Lexington-Fayette Urban County Government

PSOC Consolidation & BGA Upgrade Options

LFUCG and BGA Expansion Proposal

Lexington PSOC Expansion - Clarification Questions

Figure 1: Talk-out Coverage with BGA as multicast – 10 dB in-building

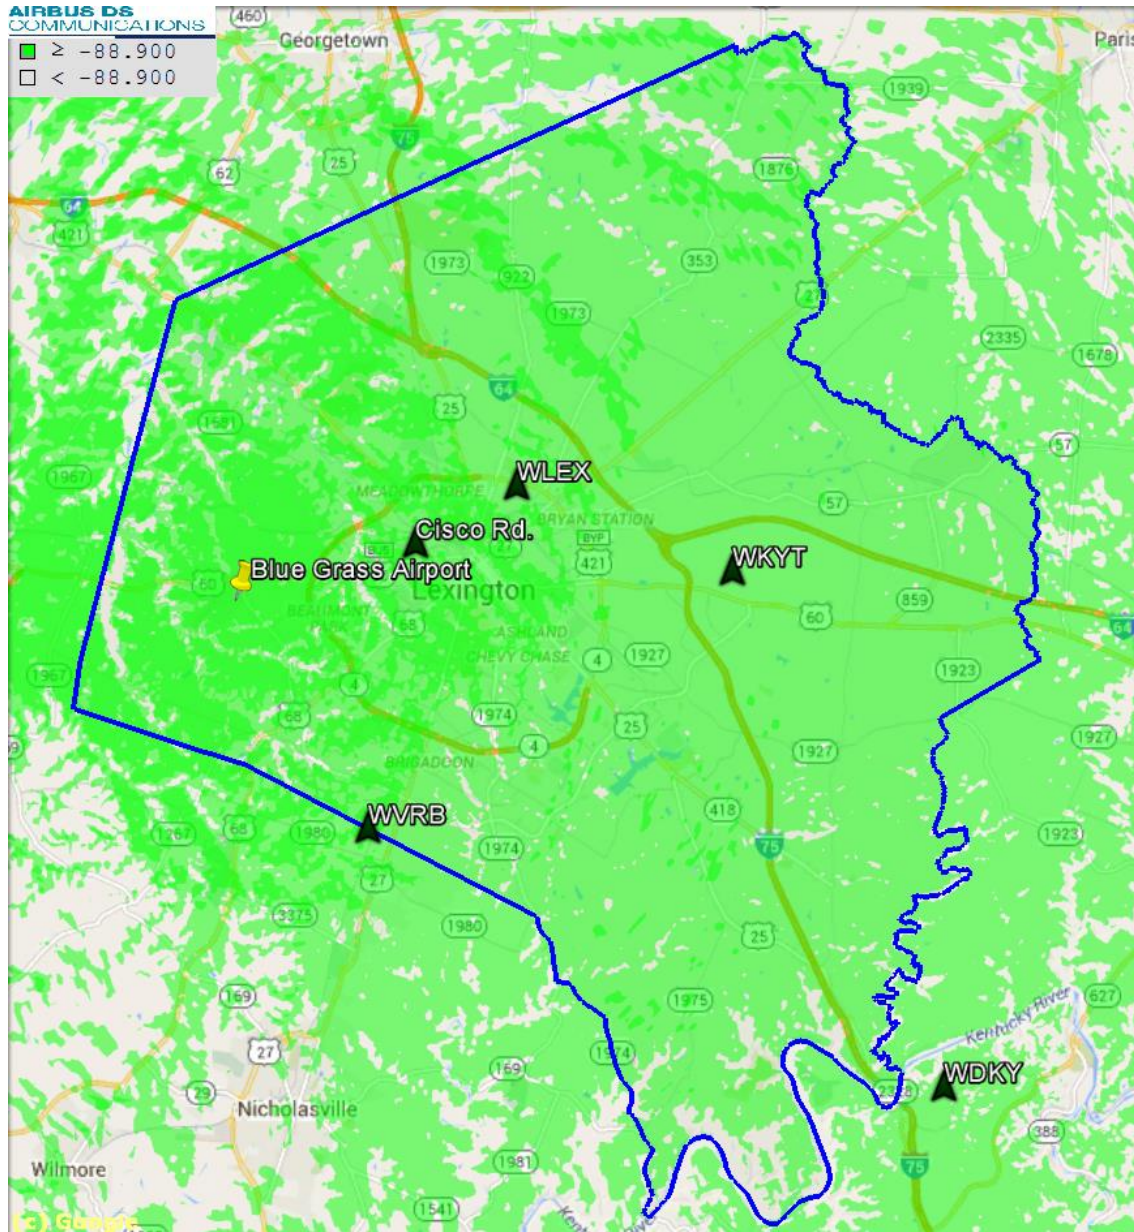
16. Do the coverage maps assume that BGA is changing to a simulcast site? If so, provide coverage maps with no change to BGA.

The coverage maps with no changes at BGA are shown below:

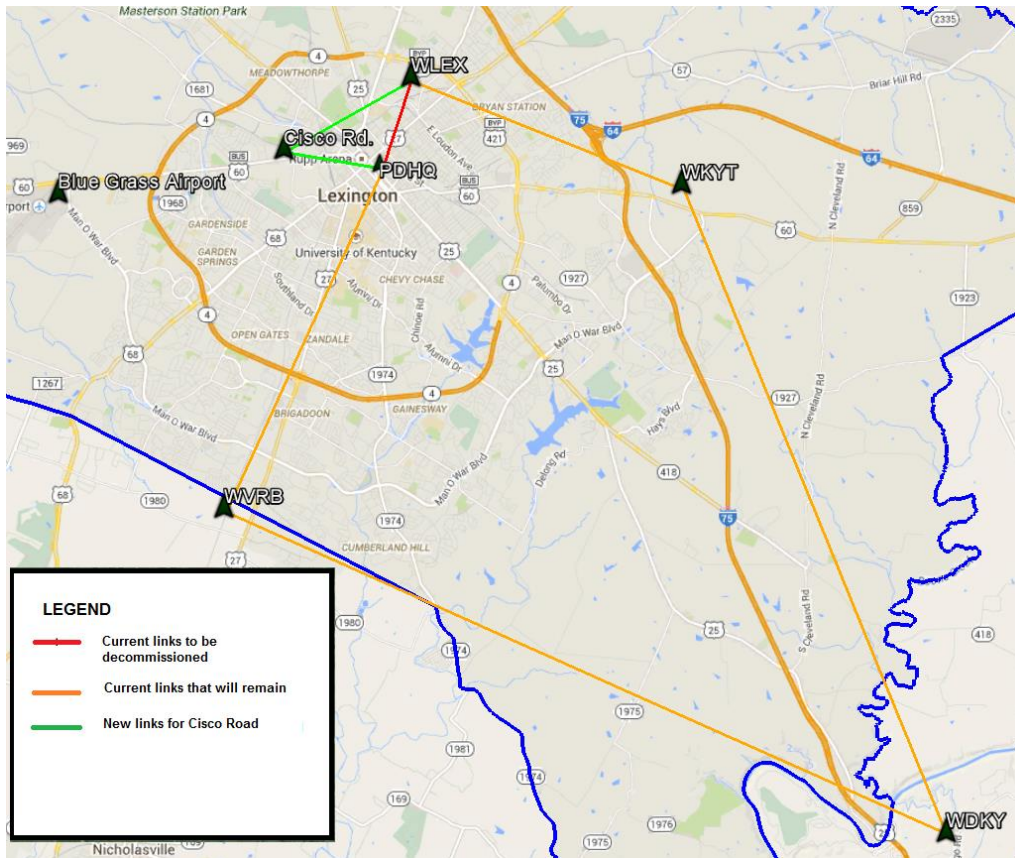
17. Confirm microwave proposal without BGA in the loop. The description in Option 2 and Option 3 should be revised to remove BGA for this deployment and confirm that frequency band for the new tower and links.

Below is the microwave topology without the inclusion of BGA in the microwave loop. The WLEX to PDHQ link would be removed and Airbus proposes to reuse the WLEX-PDHQ equipment for the Cisco Road to PDHQ link, provided that the coordinated frequencies are within the same microwave sub-band as the equipment currently installed.

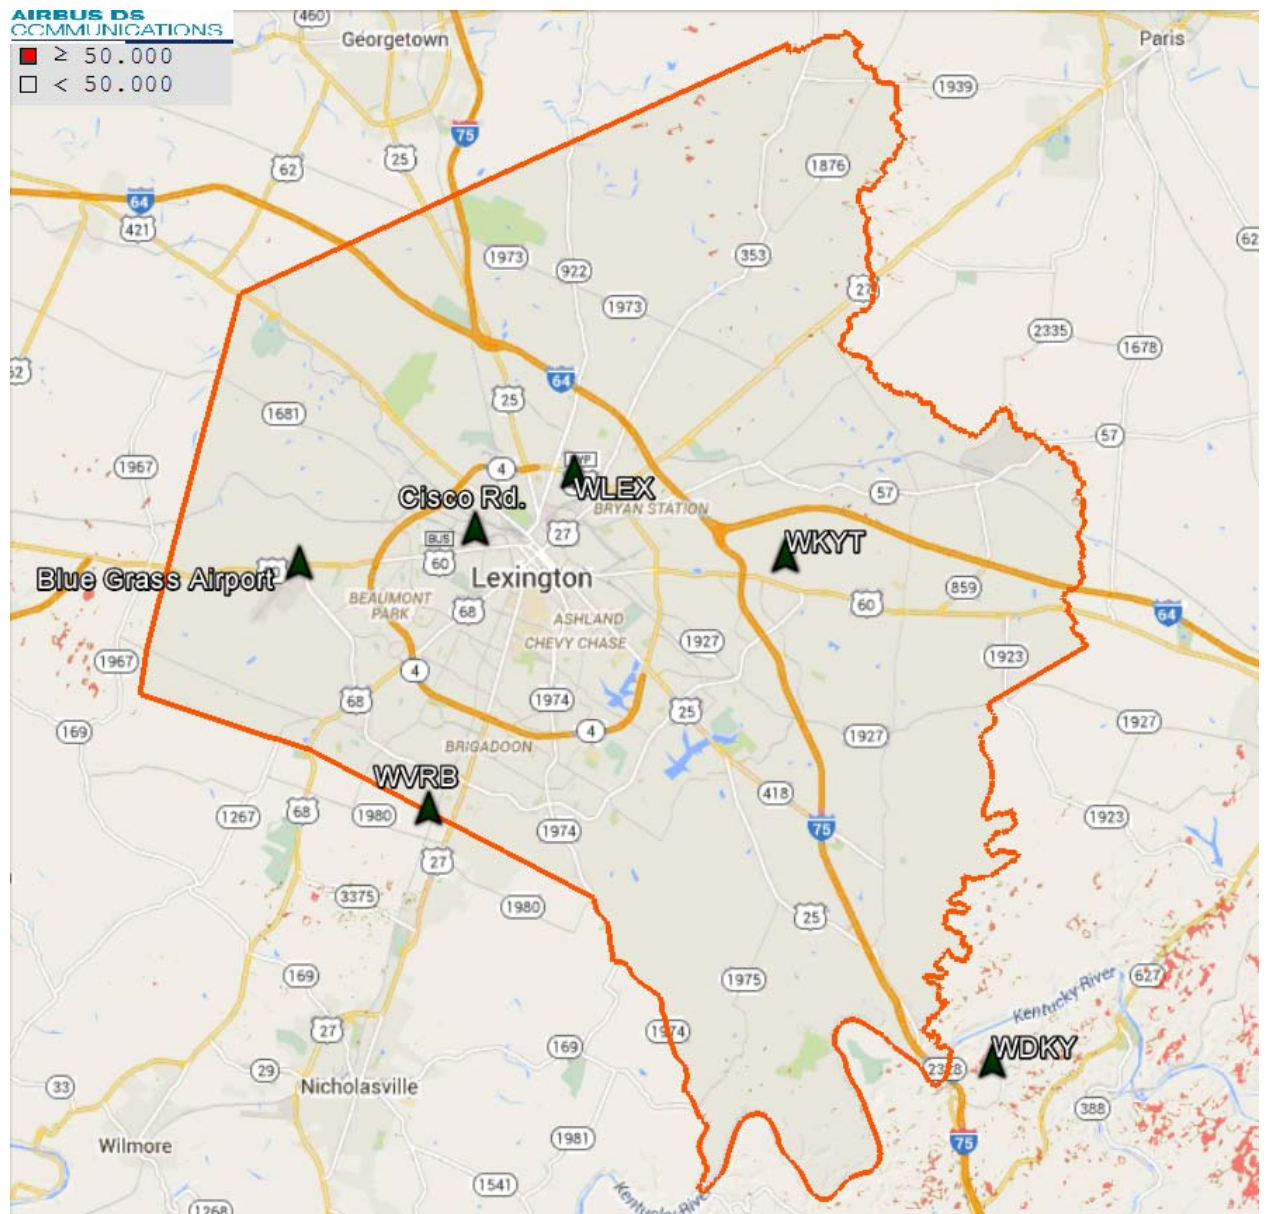
Question 13:

Airbus will provide a map that includes the expected TDI on the system. The map is shown below:
